**FOUNDATION INVESTIGATION REPORT
For**

Proposed Underpass at the Crossing of
The MacDonald-Cartier Freeway and the
Road Allowance (St. Hillaire's Rd.)
Between Lots 6 and 7, Twp. of Sidney
Co. of Hastings - Dist. 8 (Kingston)
W.J. 67-F-110 -- W.P. 67-59

St. Hilaire Road Underpass
W.P. 67-~~F~~-59 - Site 11-150
Highway #401 -
District No. 8 (Kingston)

We have reviewed your Preliminary Bridge Plan Drawing D-6438-P for the above named structure, and submit the following comment:

BORE HOLE LOCATIONS & SOIL STRATA

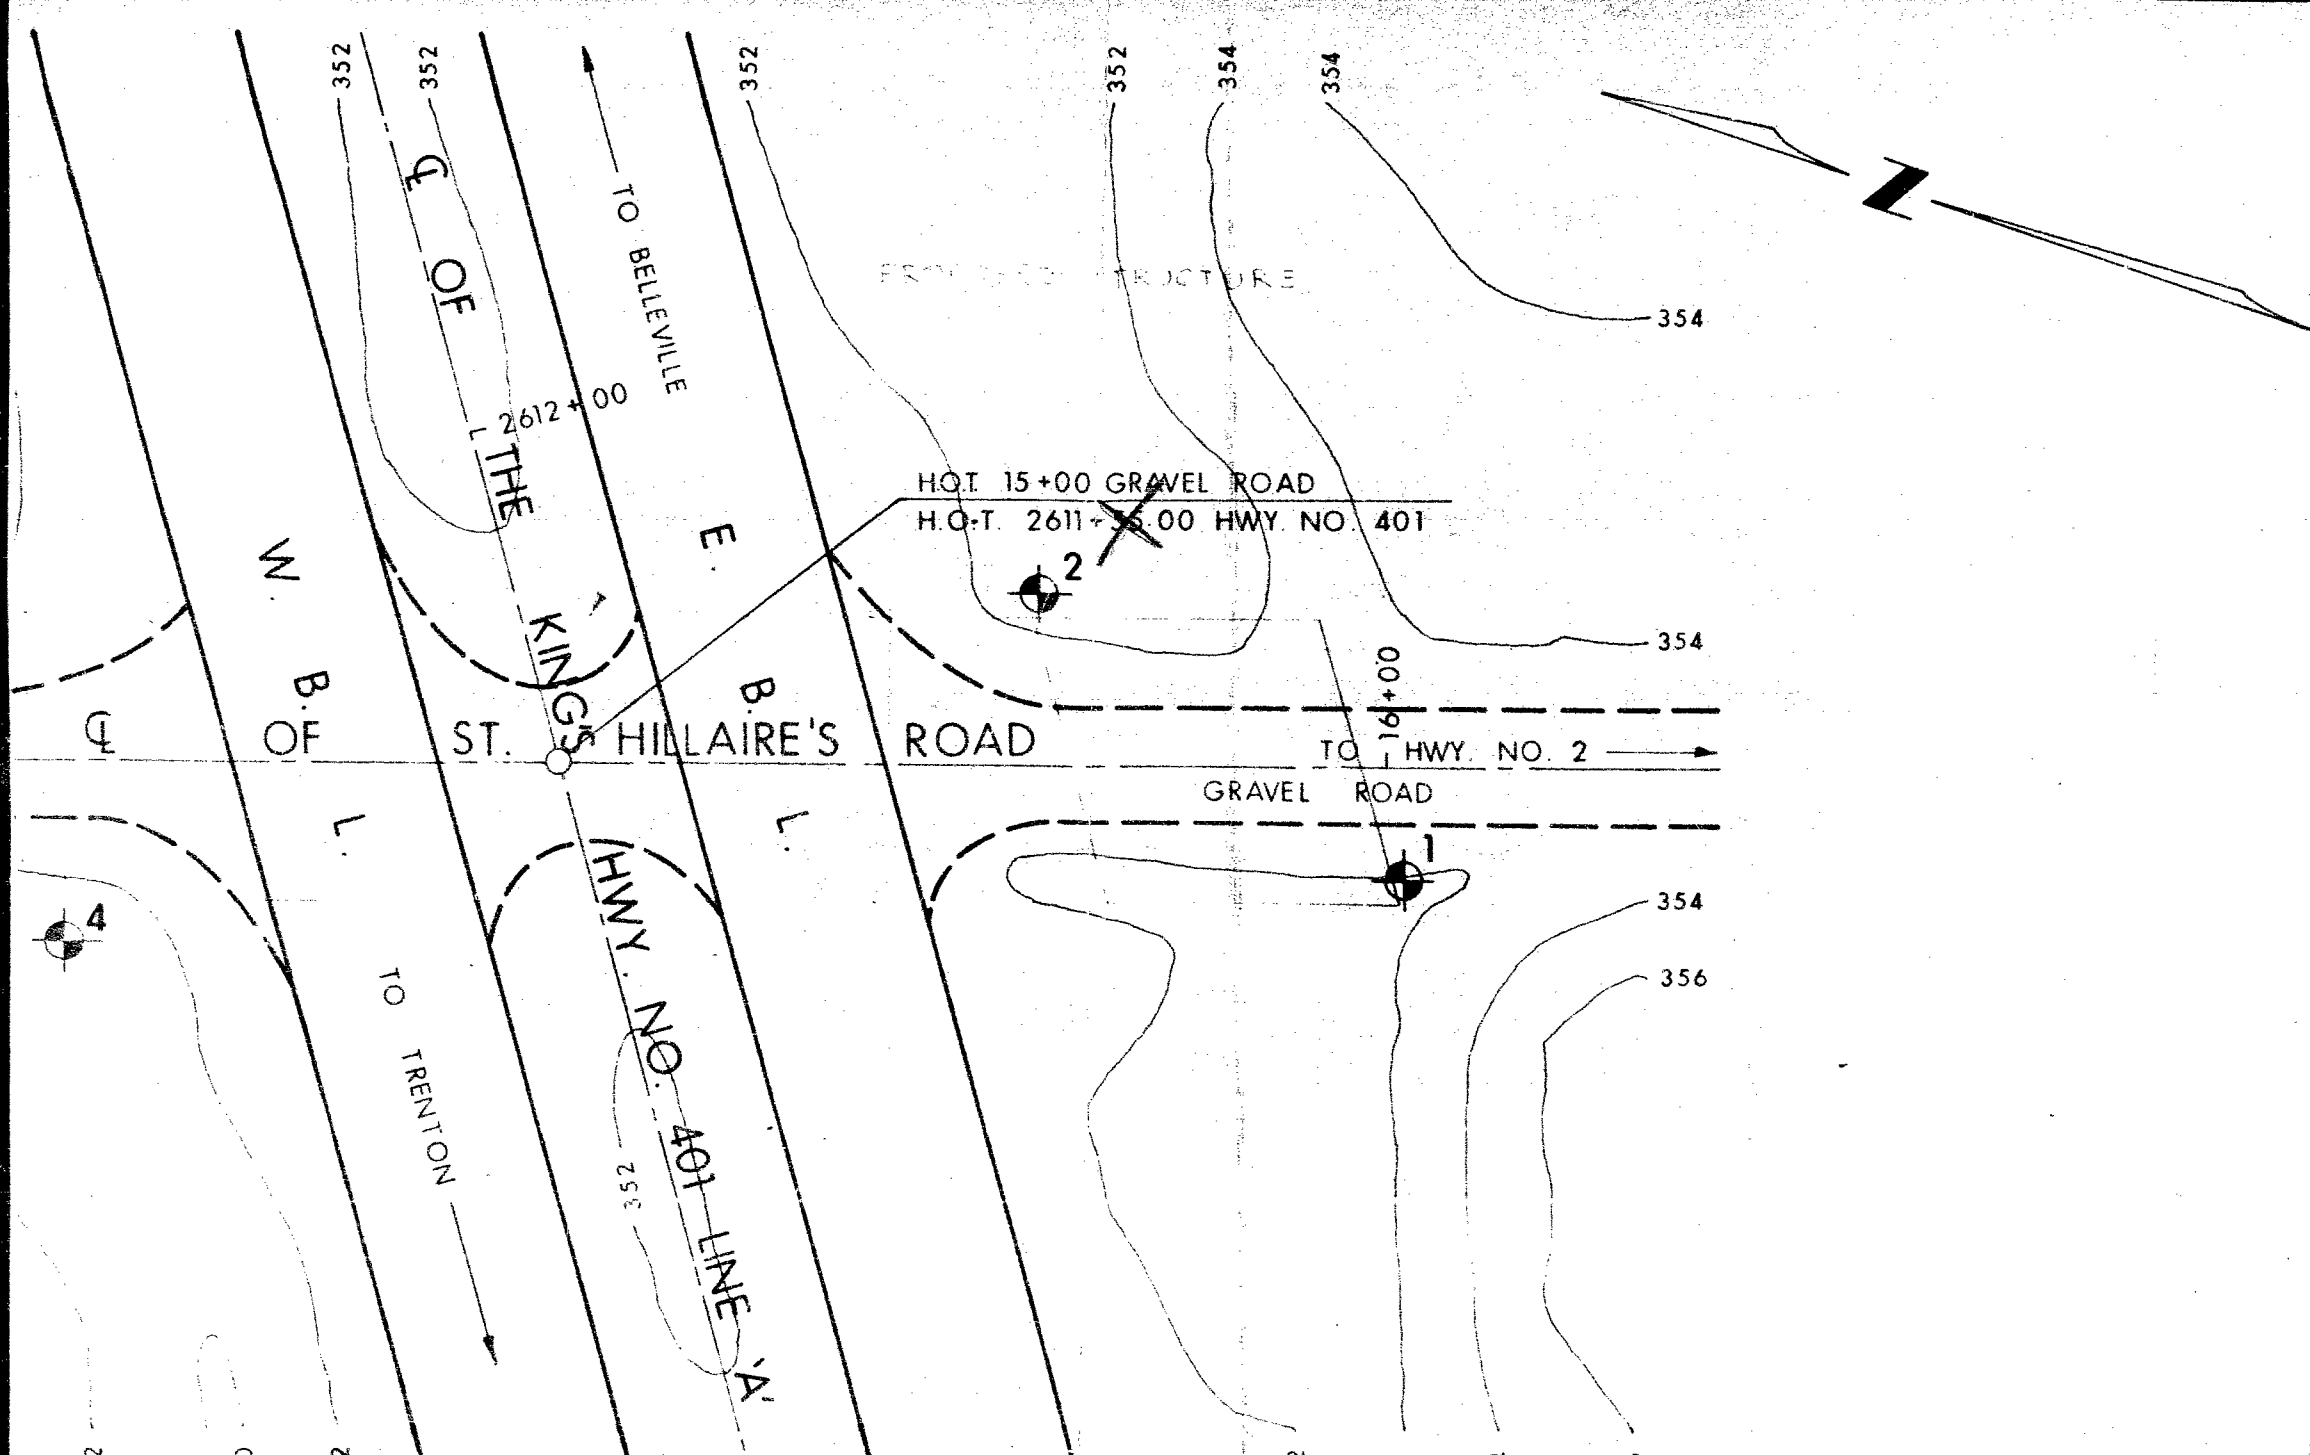
Attached herewith please find copy of Plan E-3766-1 as revised January 1968. You will please note that, whilst the physical location of the proposed structure is in accordance with our original proposal for your foundation investigation, there has been a modification to the chainage. As your Drawing No. 67-F-110A will appear in the contract documents as Bridge Drawing D-6438-2, we would be pleased if you will make the necessary revisions to the chronoflex.

*Note Change has been
reversed by Eng. Survey*

2	351.5	15 + 58	20.5' LT.
4	351.2	14 + 41	21.5' RT.
5	351.4	13 + 95	23.5' LT.
